OIL - AIR COOLED OIL COOLER MODULATING VALVE - INTRODUCTION OF AIR MODULATING VALVE
WITH REVISED 'P' SEAL MATERIAL - CATEGORY CODE 7 - MOD.ENG-79-0055

V2500-ENG-79-0055

SERVICE BULLETIN

General View
Fig.1

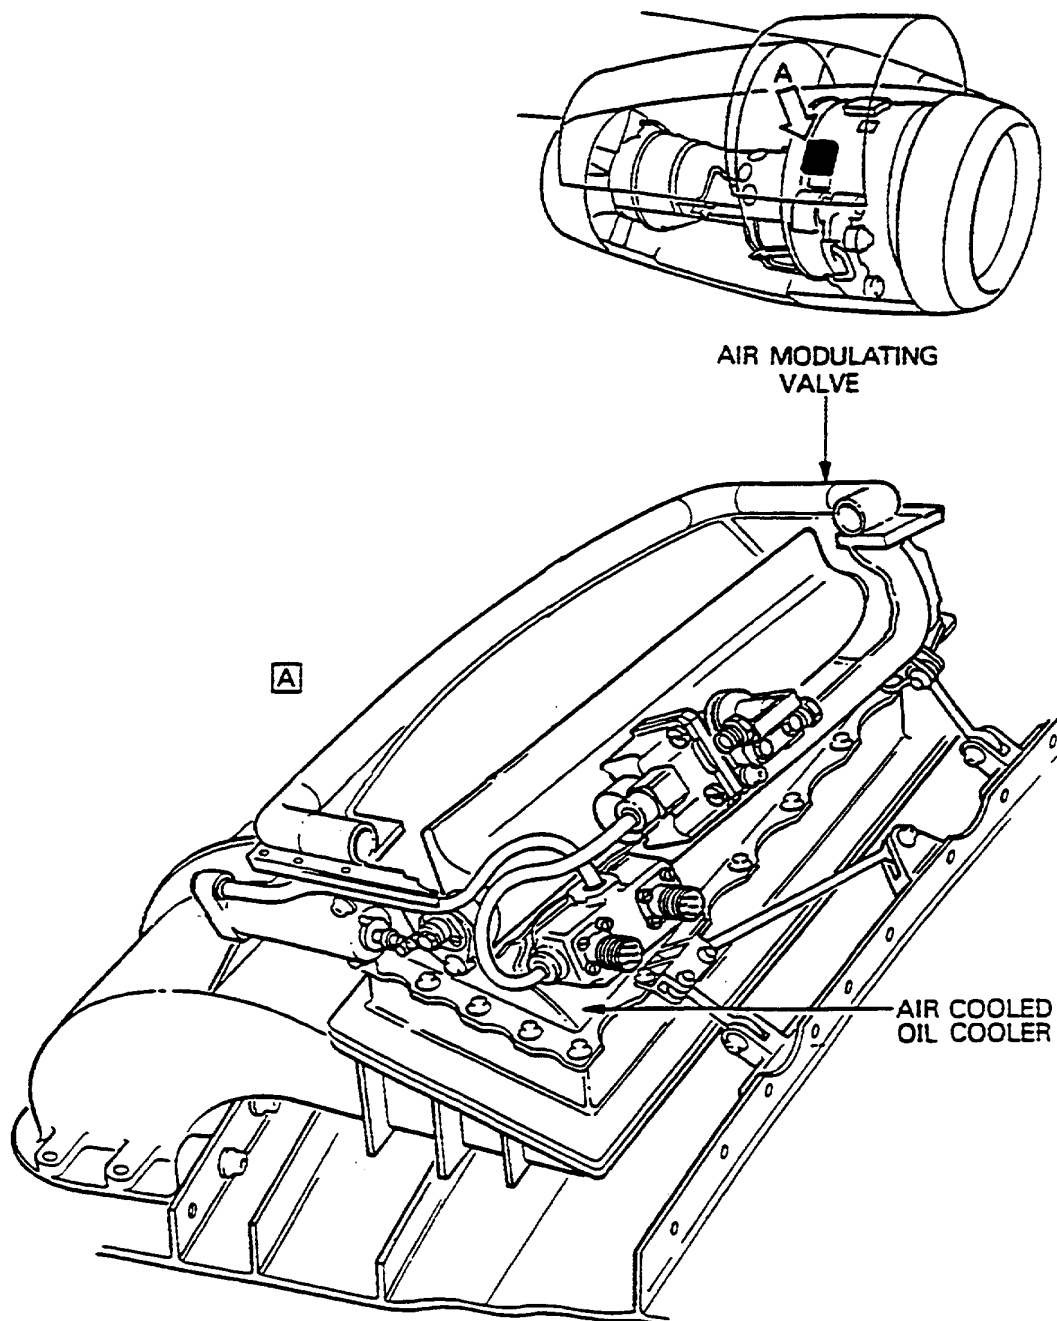
- (1) This modification covers the fitment to engines of an AMV incorporating Lucas Aerospace Mod L1795-6.
- (2) The changes introduced are:
 - (a) This modification introduces a revised AMV similar to the existing item except the fire resistant ceramic material Dalfratex used in the manufacture of the outlet flange mounted 'P' seal has been changed to the fire proof ceramic material Tygasil.
- (3) Units incorporating this modification will be identified by endorsement of the modification plate with L1795-6.
